Subject: Review and comments on Six-Month Pumping Test of Testing Well East (TW-E) at Owens Lake, Revised Testing Plan, May 2020.

Subject: Additional Comments on Six-Month Pumping Test of Testing Well East (TW-E)

Subject: Operational Test of Testing Well TW-E at Owens Lake - Updated Testing Plan

**Testing Well TW-E  
Northwest Owens  
Lake Fault Lines**

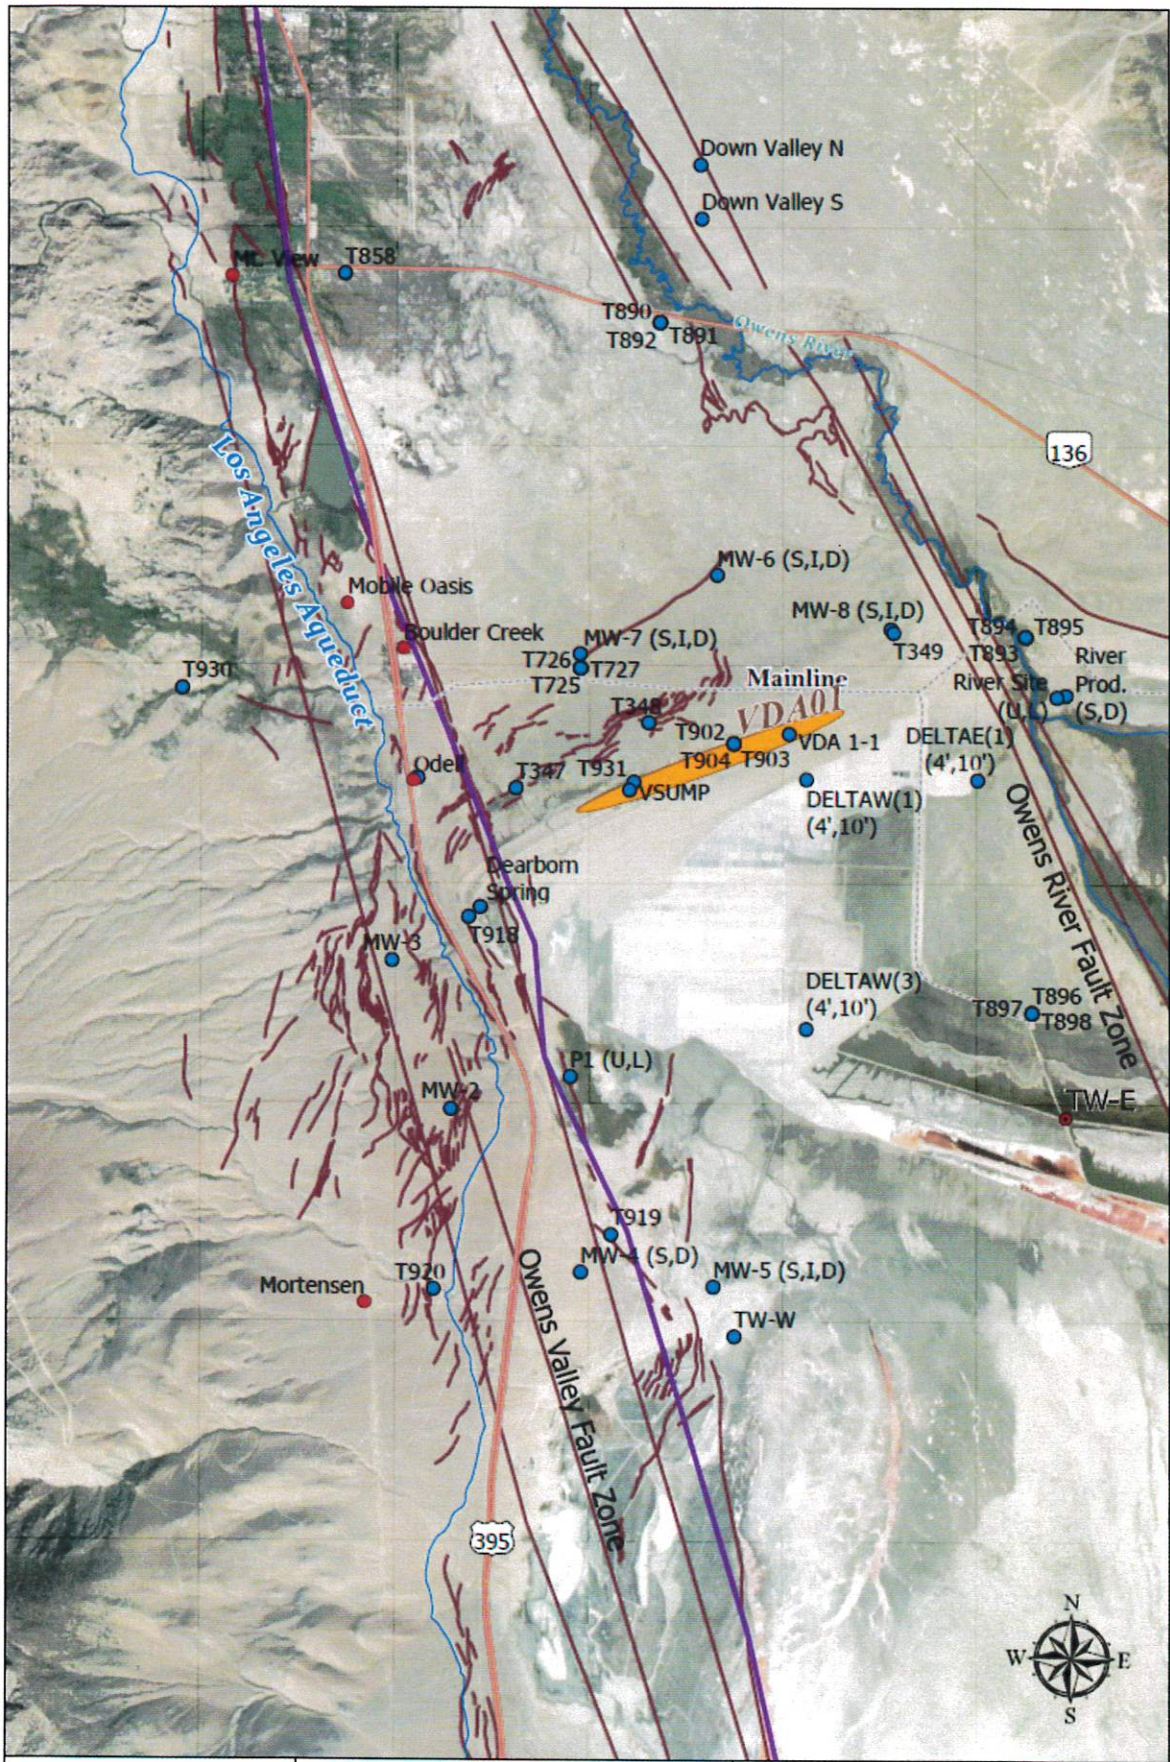
3. Impact of Faults. All but one well is located west of Owens Valley Fault Zone

*The fault zones shown in the document are general in nature. Please see the attached more detailed map showing the Owens Valley Fault Zone (OVFZ) and various splays of the fault zone. The main splay of OVFZ is the near-continuous 1872 ruptured section (eastern splay) based on multiple sources of evidence reflected in the geology and groundwater studies. As shown on the map, there are multiple monitoring wells located west of the main splay, which show very different formation lithology, water levels, and water quality as opposed to corresponding monitoring wells located east of the splay. Monitoring data from these wells during the operational test will be used to determine the effect of the fault as a barrier to groundwater flow.*
